| <b>Title - Sujet</b><br>Col-12 Contaminated Soil Disposal   |   |
| <b>Solicitation No. - N° de l'invitation</b><br>EZ113-151591/A  | <b>Amendment No. - N° modif.</b><br>002                                   |

This Amendment 002, Addendum 001 is raised to provide clarification to questions received from prospective bidders.

**FOCUS**  
TOPOGRAPHIC SURVEY  
COL 12 SITE, DND

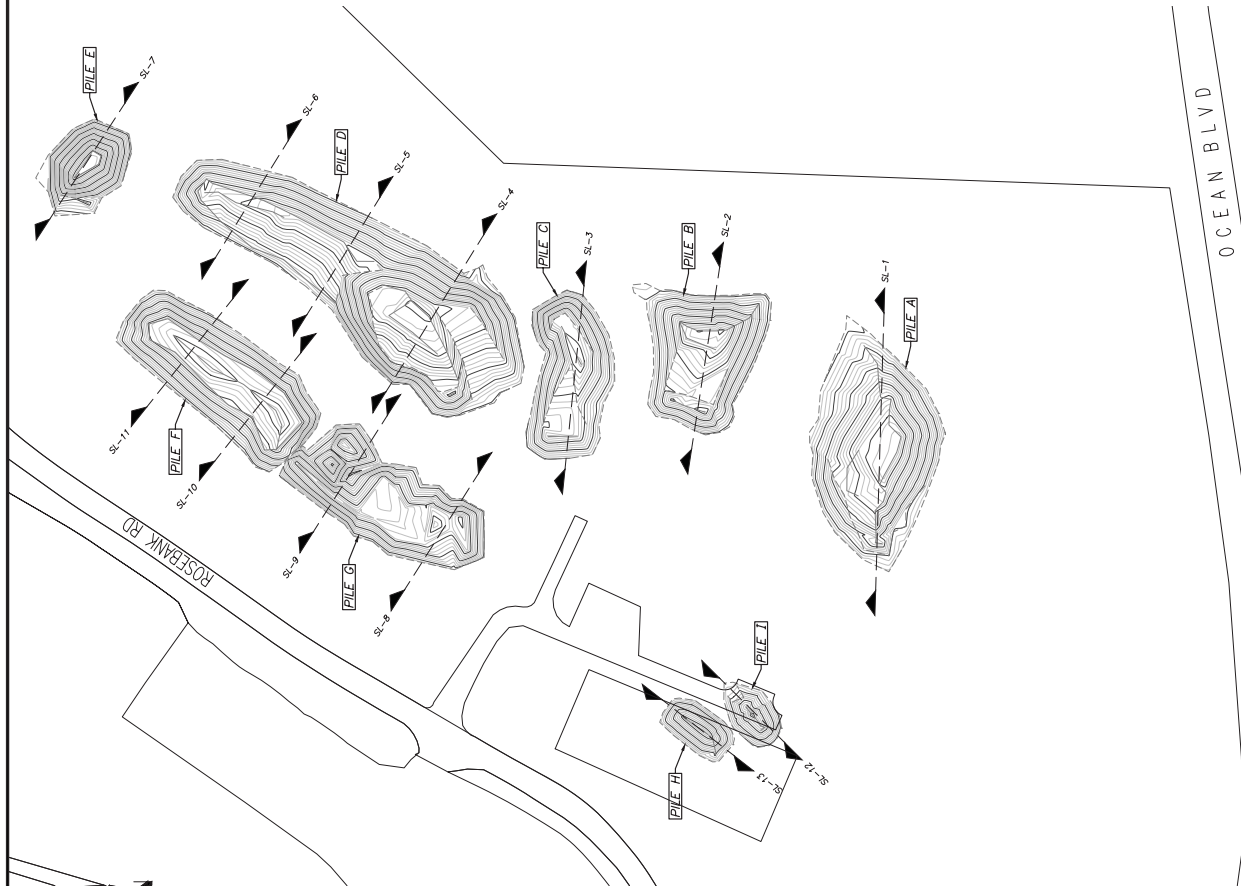
Upon review of the tender documents and amendment 1 and 2, QMLP is unable to correlate the 10,674 metric tonnes of contaminated soil from line item 6 to stockpile quantities provided in SLR's report. Please clarify which specific stockpile IDs will be loaded, transported and disposed of under this tender.

The total tonnage of CL+ material to be disposed of is restricted to 10,674 tonnes under this project. The work stated in the Specs requires partial removal of the CL+ stockpiles which will include all of SP-3 (Pile D in the attached) and most of SP-1 (Pile E in the attached).
